SR 30/US 280 @ Oconee River & Overflows

BR000-0001-00(366), P.I. No. 0001366
Wheeler & Montgomery Counties, Georgia

Value Engineering Study Report

September 2010

Sketch
 Alt. A-2 2/16

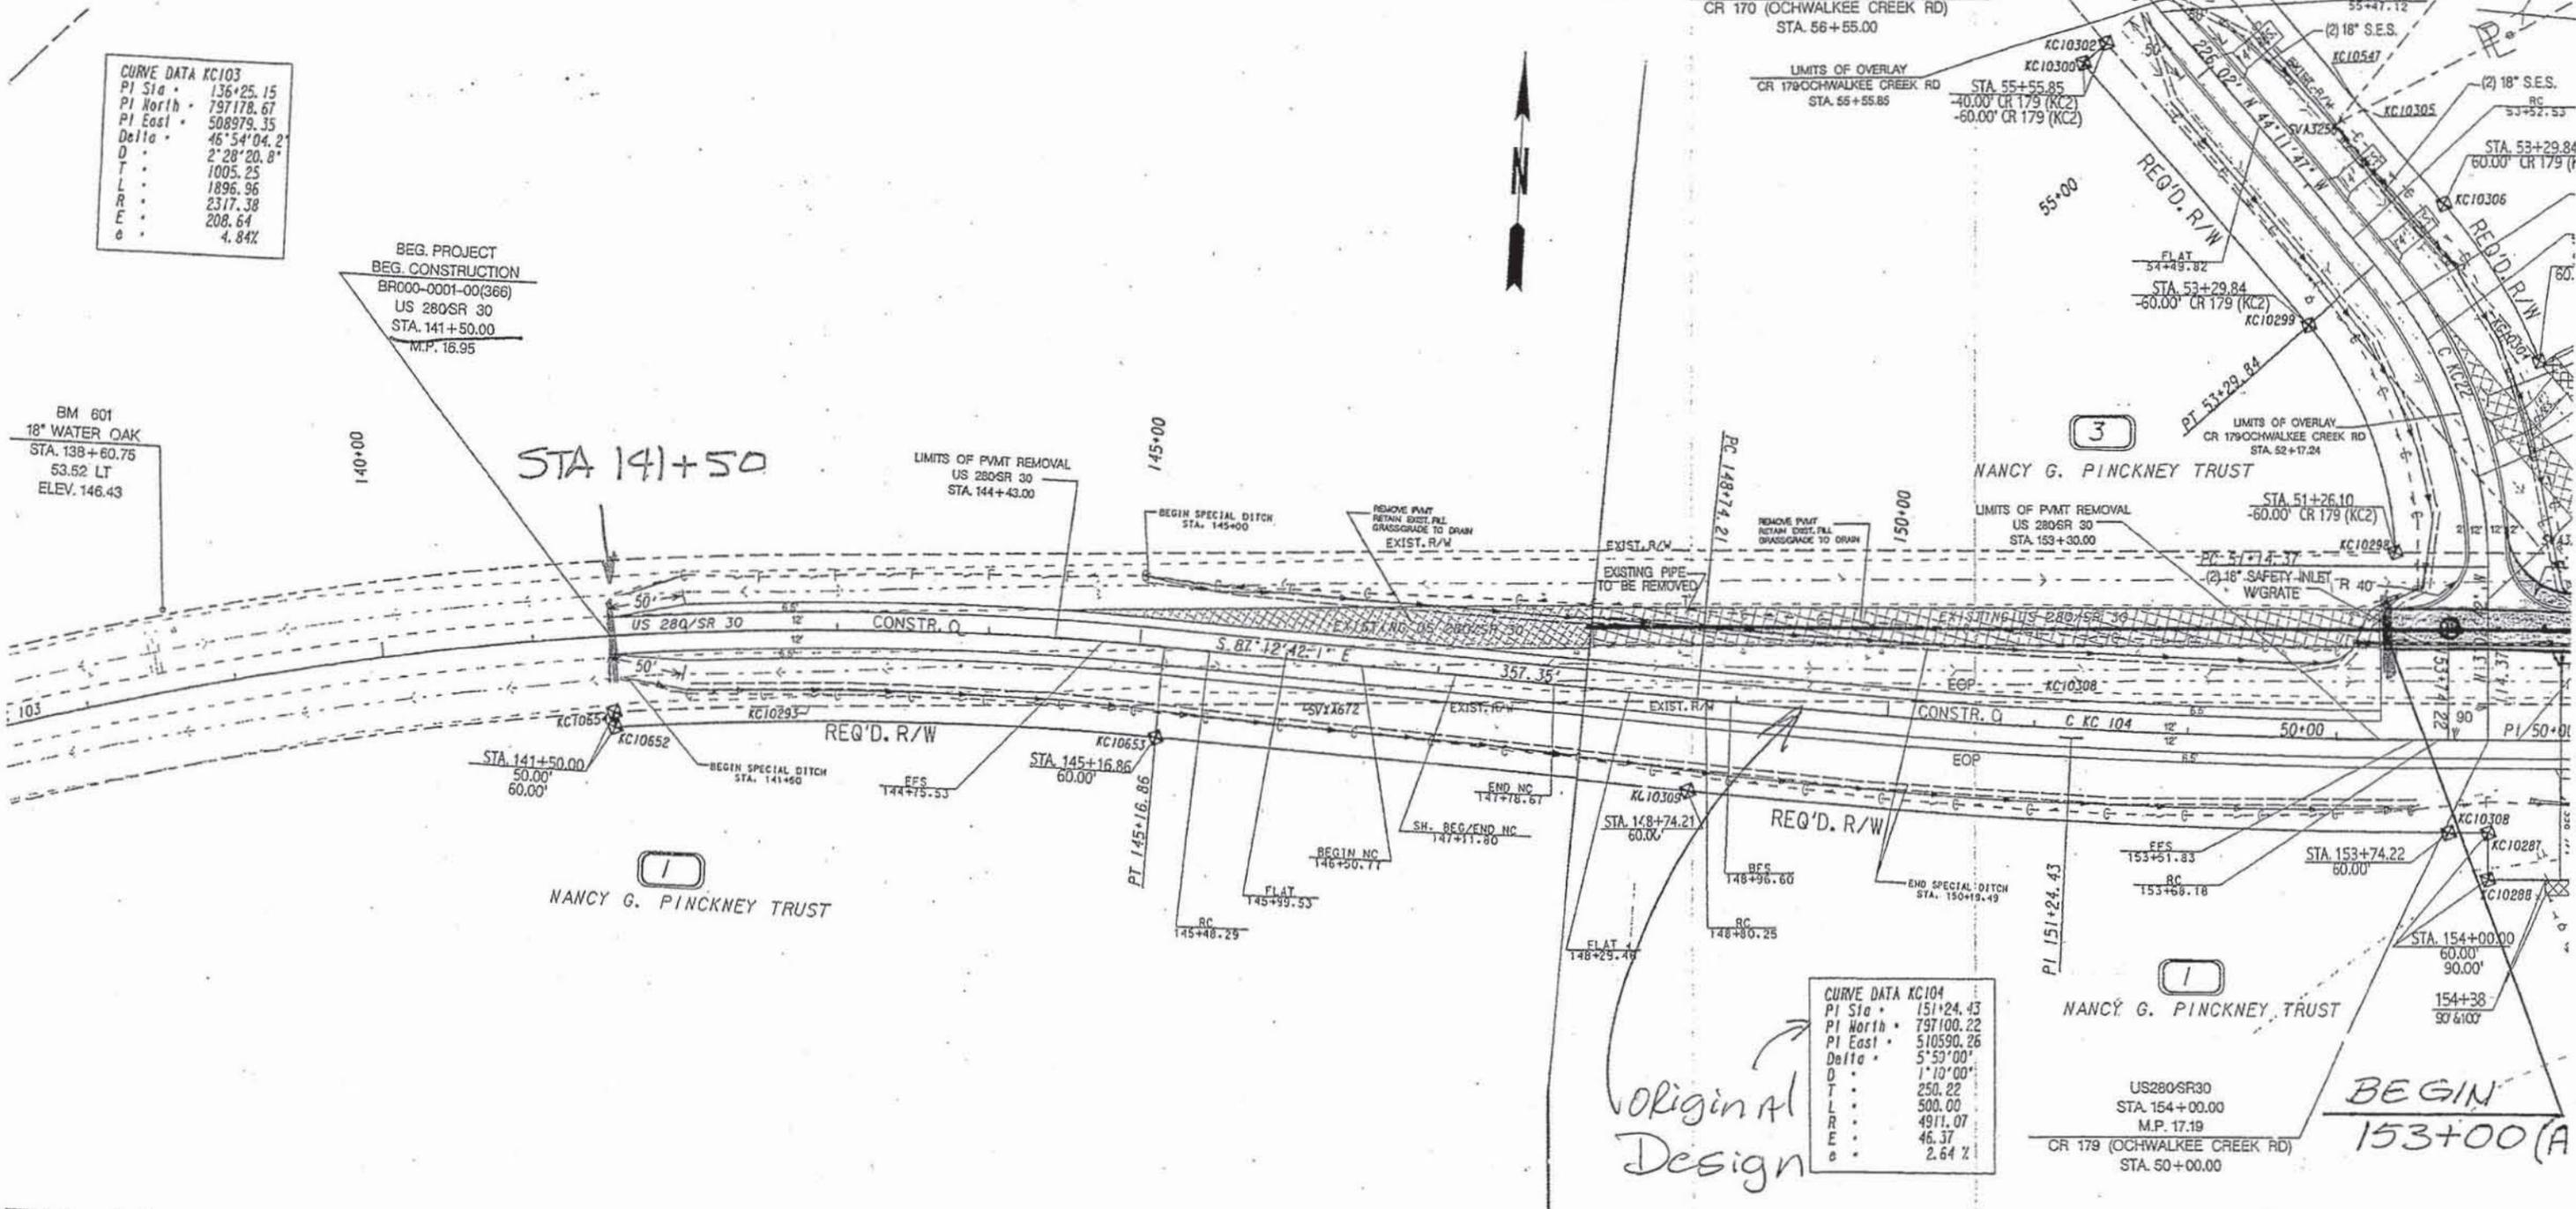
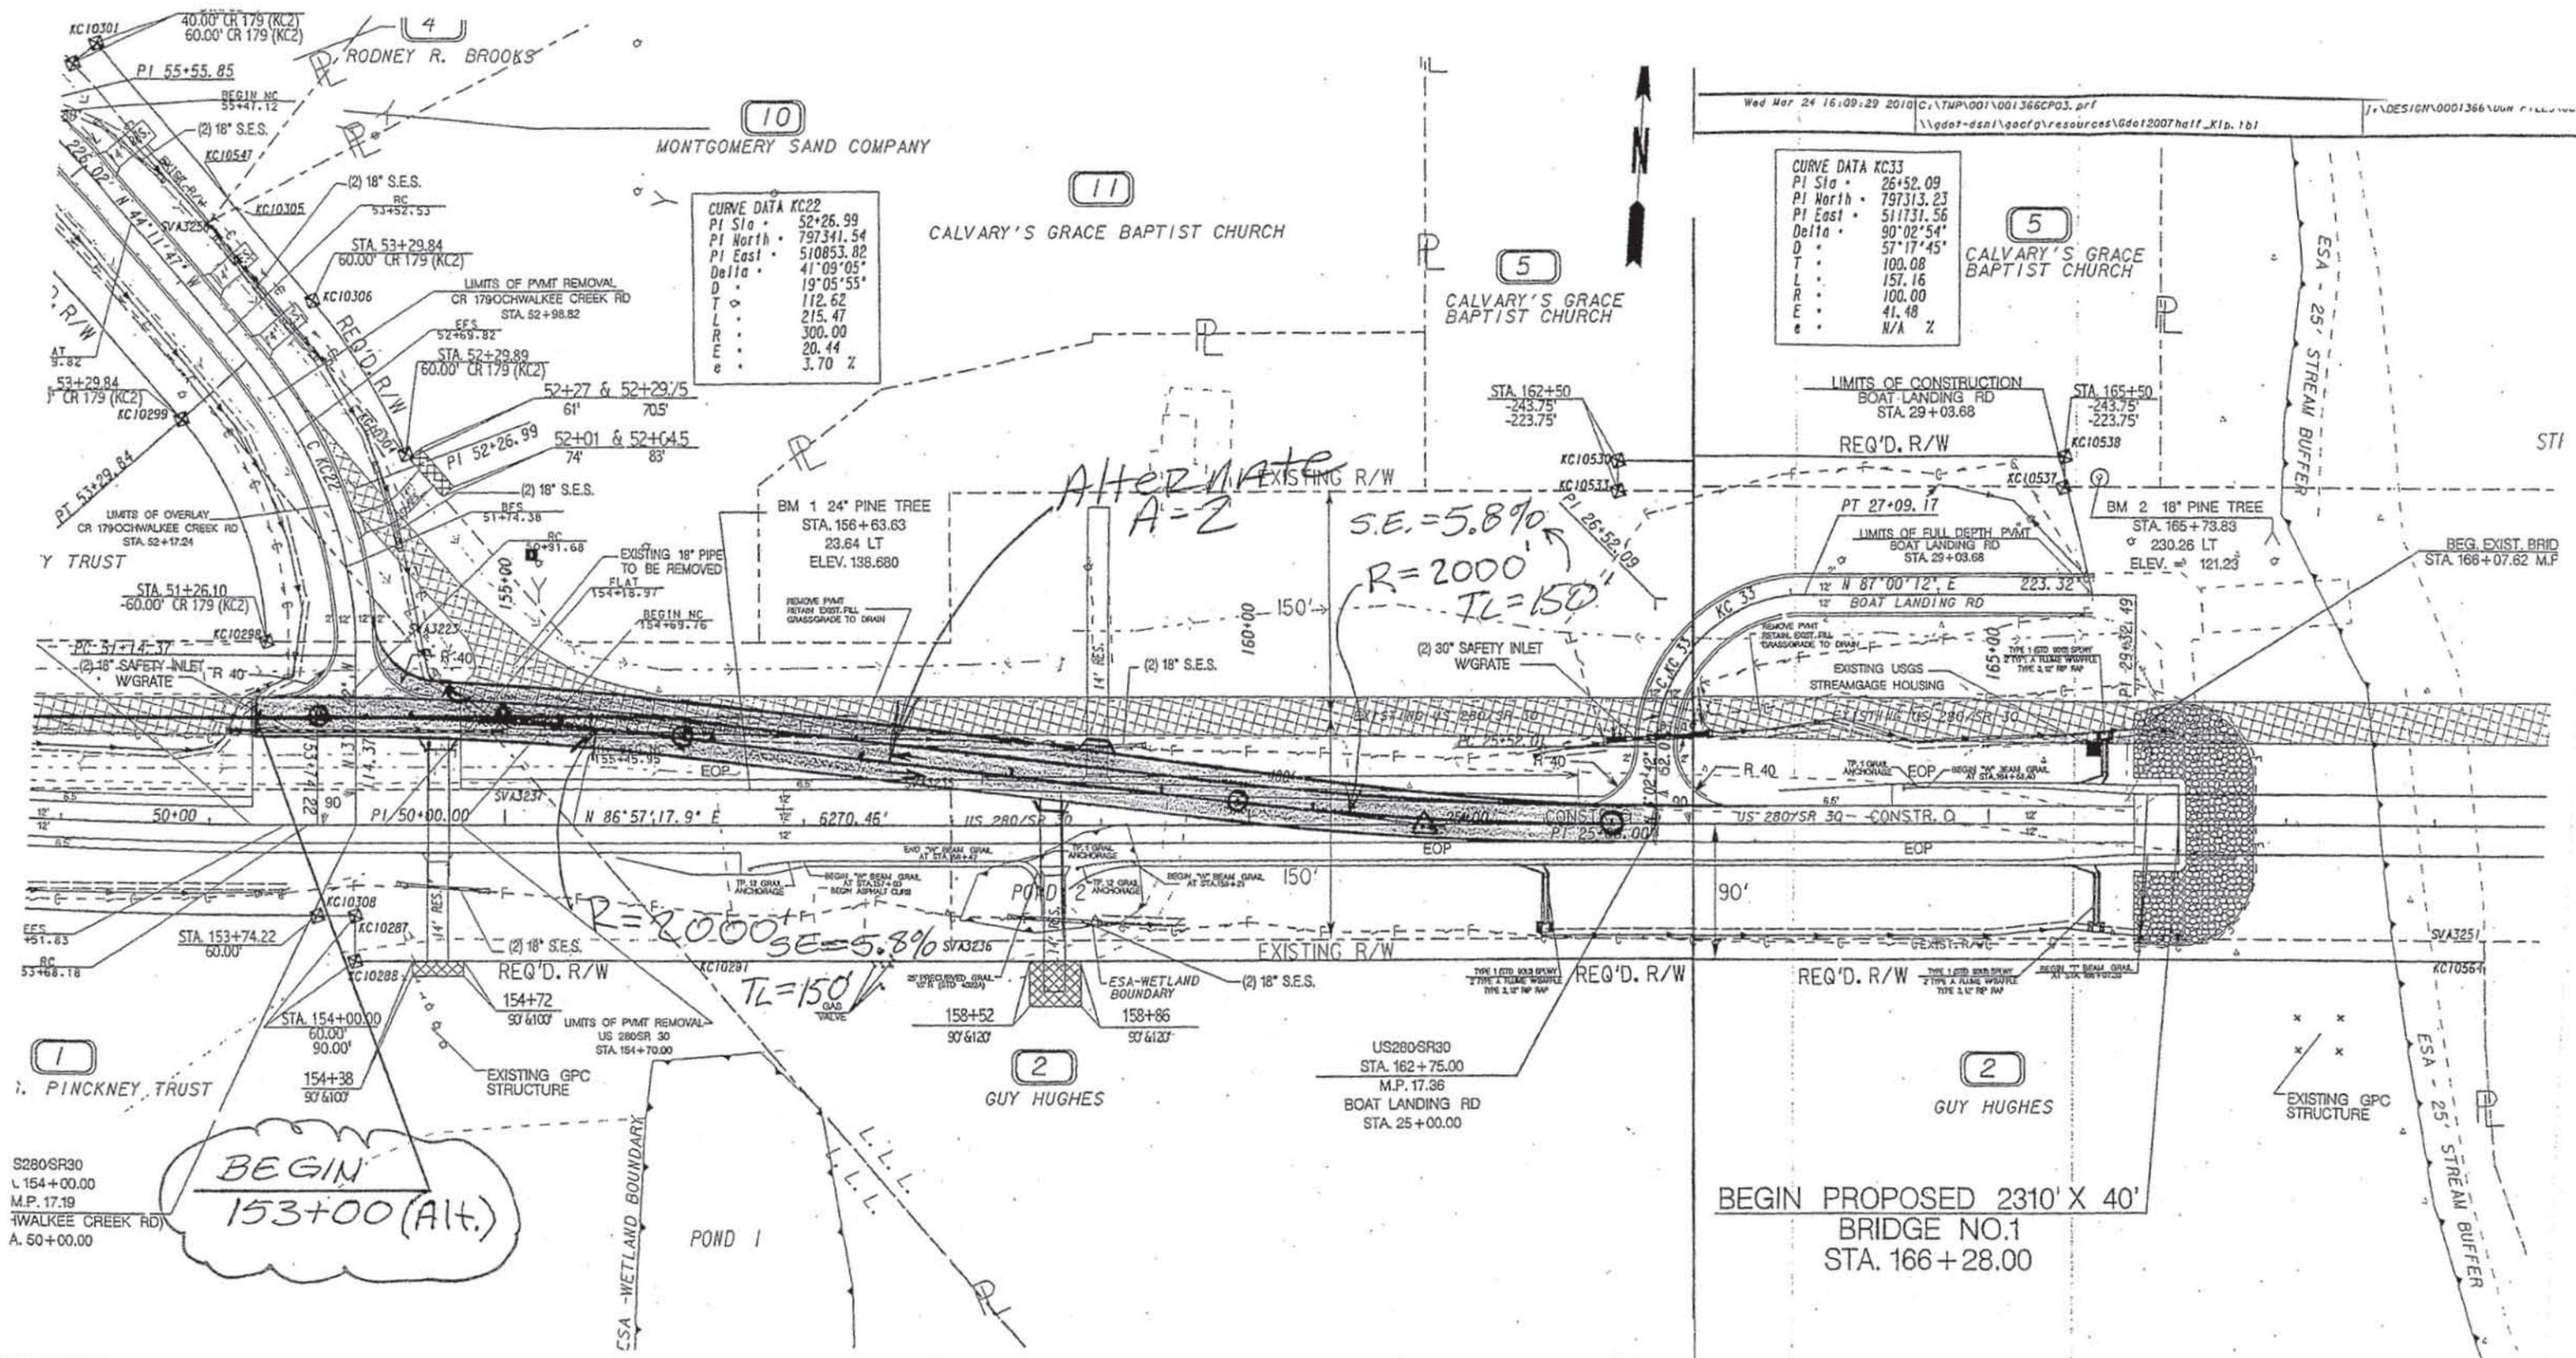
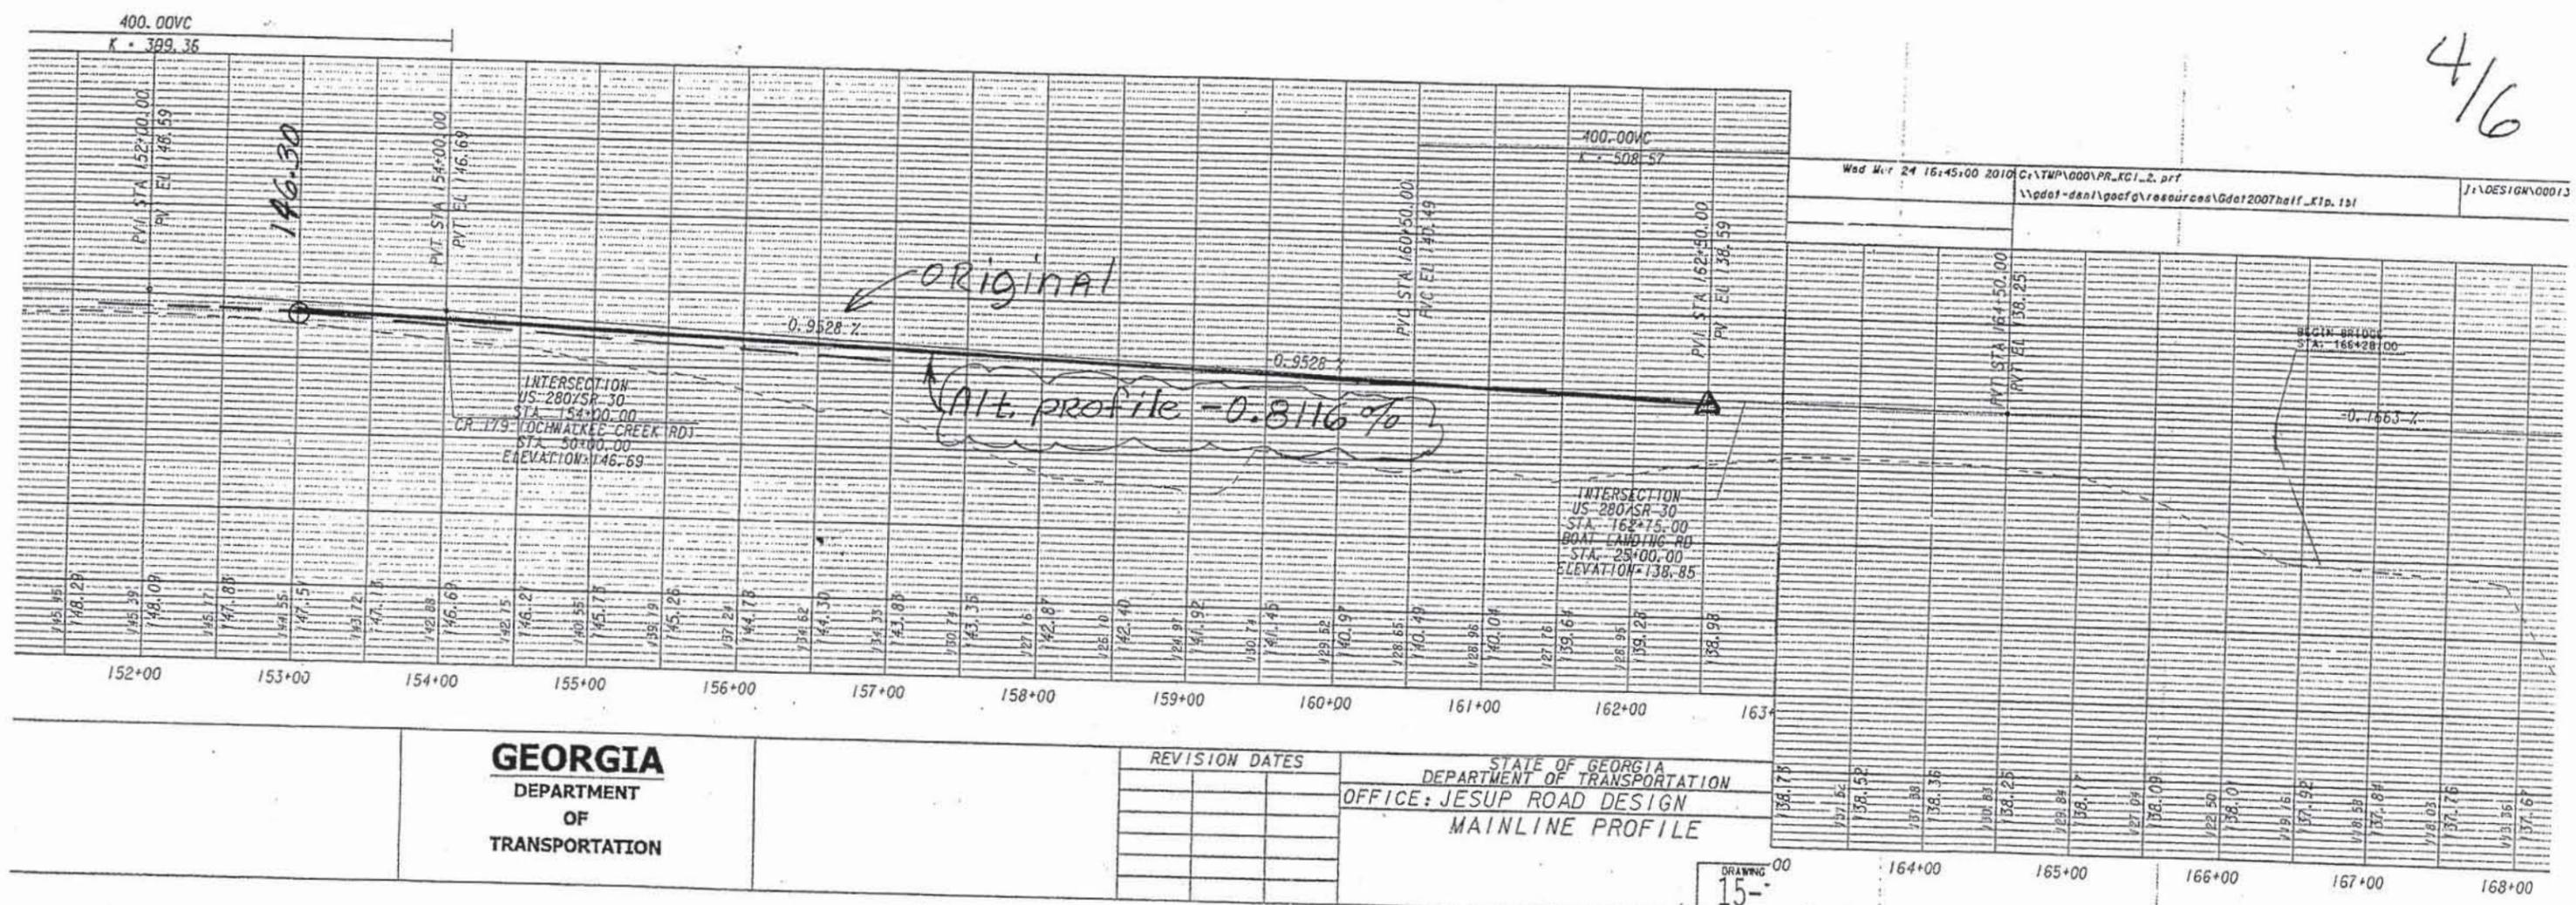
DESCRIPTION: SHORTEN THE PROJECT LENGTH BY 1,150 FT. BY
 MOVING THE BEGINNING POINT ON THE WEST END
 FROM STA. 141+50 TO STA. 153+00 AND SHORTENING
 THE ROADWAY APPROACH TO THE MAINLINE BRIDGE

The new roadway approach begins at Station 141+50 and the total project has a length of 1.68 miles.

Begin the project at Station 153+00 and shorten the project by 1,150 ft. Reduce the total project length to 1.48 miles.

The current design uses 2,450 ft. of new roadway alignment to tie the existing SR 30/US 280 into the new mainline bridge. This alternative would require only 1,400 ft. of new roadway. The alternative design for the horizontal alignment uses two 2,000 ft. radii with 5.8% super elevation for 55 mph. If a design speed of 65 mph is desired, a 2,000 ft. radius with more super elevation could be used. However, the alternative roadway design is appropriate for existing conditions using a posted speed of 55 mph. The alternative design retains the provisions for a right-turn lane onto CR 179.
